BOARD OF ADJUSTMENT AGENDA

Board of Adjustment Regular Meeting - Thursday, April 27, 2017 - 6:00 p.m.
City Hall - City Commission Chambers, 100 North U.S. #1, Fort Pierce, Florida

SUBJECT: **Application for Variance**
Stover Residence - Fence Height & Side Yard Reduction for Accessory Structure
3141 S Indian River Drive

Site Plan & Landscape Plan Set

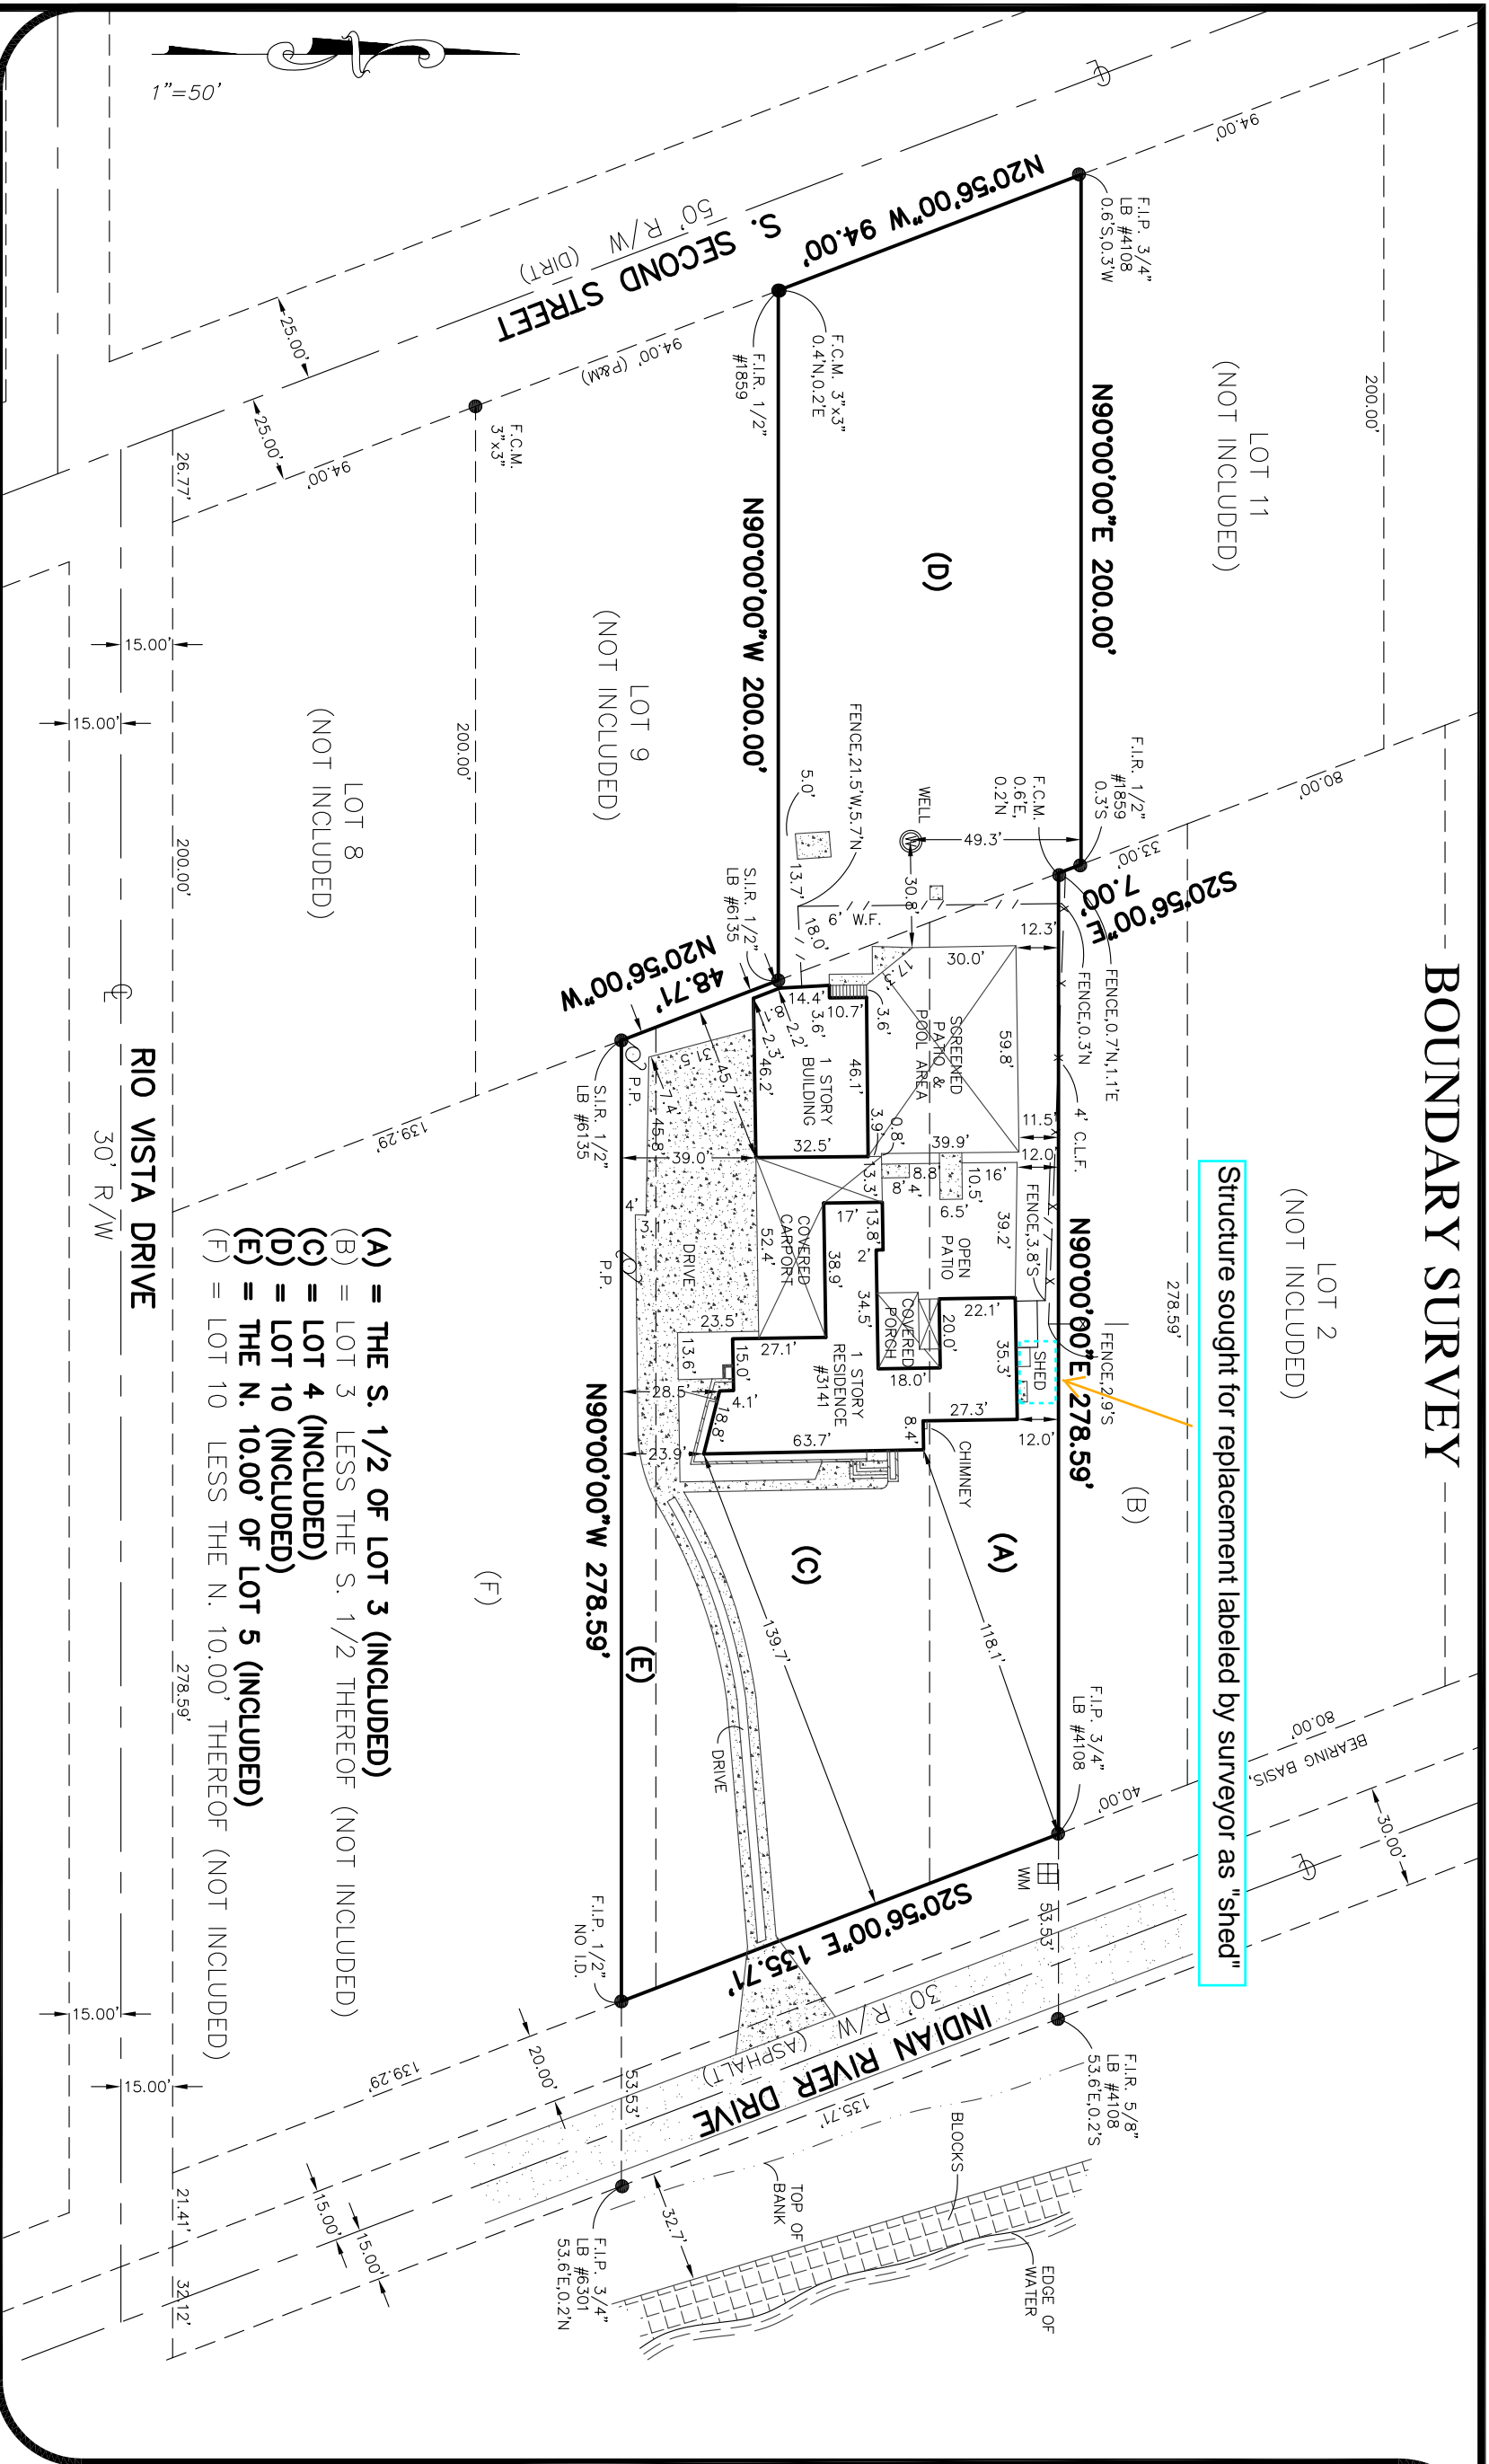
As you can see from the photo, the slider to the orchid house is raised due to being on a deck flush with the top of the tub, approximately 4 ft above the surrounding soil. With only a six foot fence, people stepping into or exiting the tub will be clearly visible. It has custom stained glass surrounding the slider which would be obscured by curtains, and the intent of the slider is to allow the bather to enjoy the view of the orchid house. Frankly, this very nice feature of our home will be compromised and made foolish rather than desirable if we cannot replace the orchid house. Failure to achieve this variance will detract from our use of the property and will compromise property value.

The recommendation of Staff is to grant **approval** of the requested variance to permit the reconstruction of an existing "orchid house", or fence and pergola, at the north end of the home to maintain a screen between the neighboring property and the master bathroom, based upon the justification presented by the applicant with respect to the criteria for granting a Variance specified in Section 22-108.

Figure 1 – Staff Recommended Adjustments to Site Plan

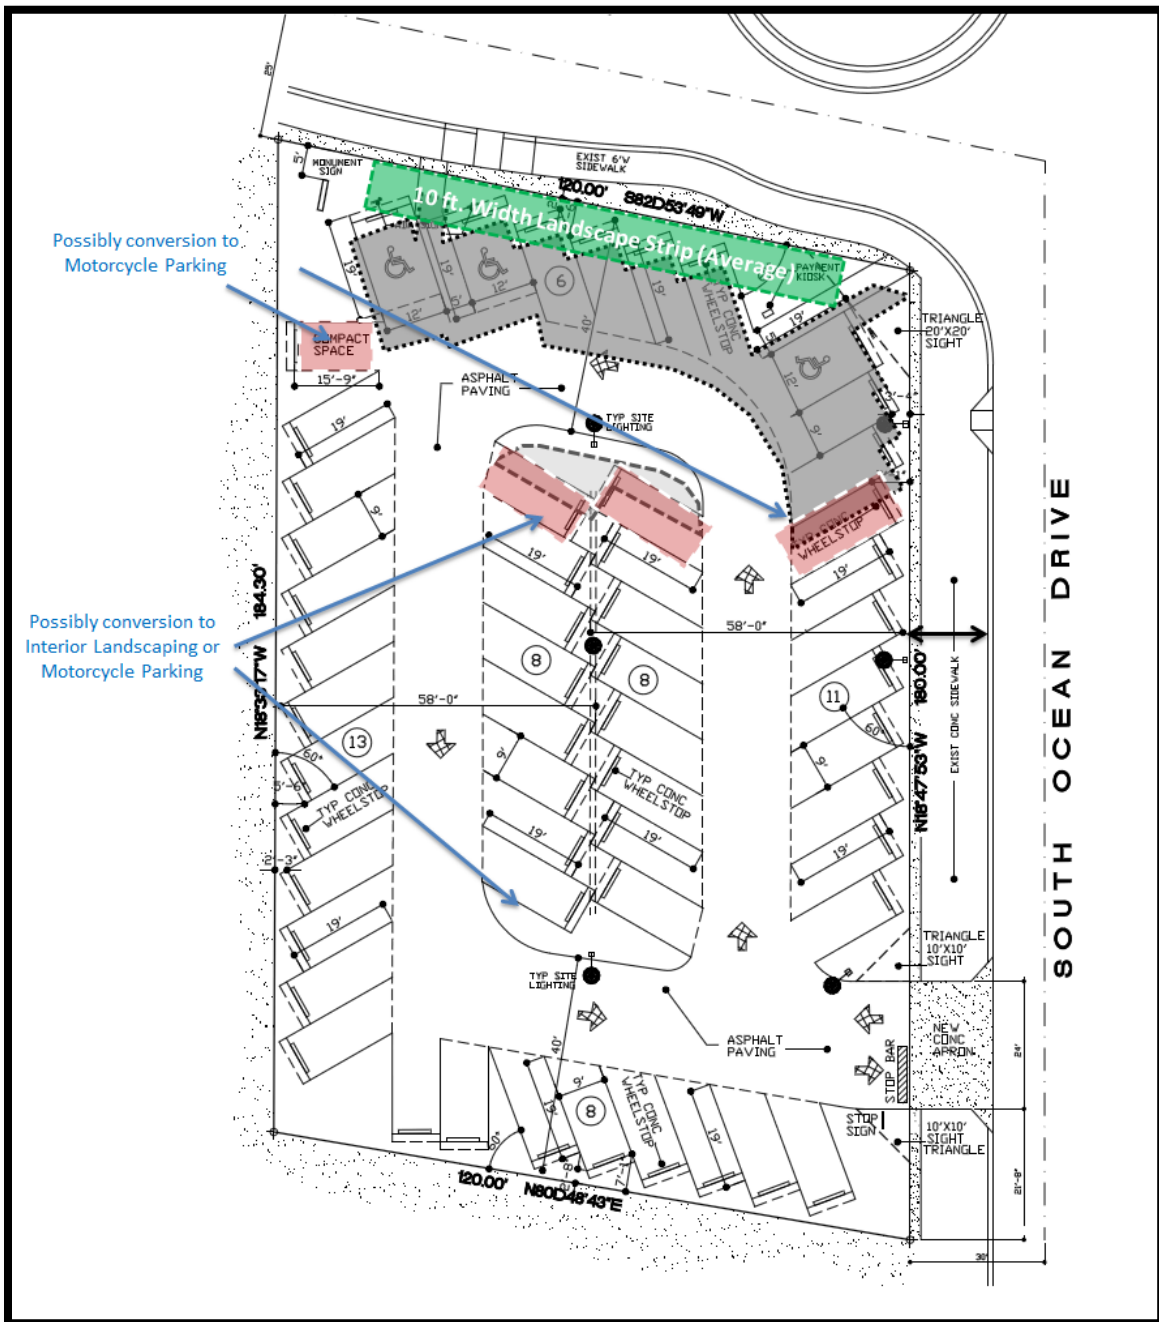
The variance deliberated by the Board of Adjustment should be consideration of the minimum variance that may make possible the reasonable use of the land. The reduction of the eastern landscape strip provides for the added capacity for an entire row of parking spaces (10-11), whereas the reduction along the northern property line only expands the quantity of parking spaces by four (4), with one of said spaces designed as a significantly compact space. The applicant retains the capacity to install the code required trees and shrubs within the remaining areas provided, which would be complimented by the existing Royal Palms present in the right-of-way. The reduction of the landscape buffer required at the northern property line only renders a four (4) parking space advantage, whereas the reduction places a line of vehicle parking spaces towards traffic traveling towards the Jetty Park Area. The reduction of four (4) parking spaces would provide necessary space to meet

the required landscape at the northern property line and interior vehicular use area. A conceptual demonstration of this adjustment is provided below in Figure 1.

- Elimination of four (4) parking spaces noted in red in order to provide a 10 ft. (average) landscape buffer along the northern property line, or primary entrance to the Jetty Park area
- Minor of Parking area south, and further expanding the interior landscape area to meet minimum requirements.

4) The site plan is amended to provide a landscape strip along the northern property line which averages a minimum width of ten (10) feet and the required interior vehicular use area landscaping. This adjustment further provides resolution to Technical Review comments #2 & #3 provided by the Engineering Department on April 17t, 2017 (attached).
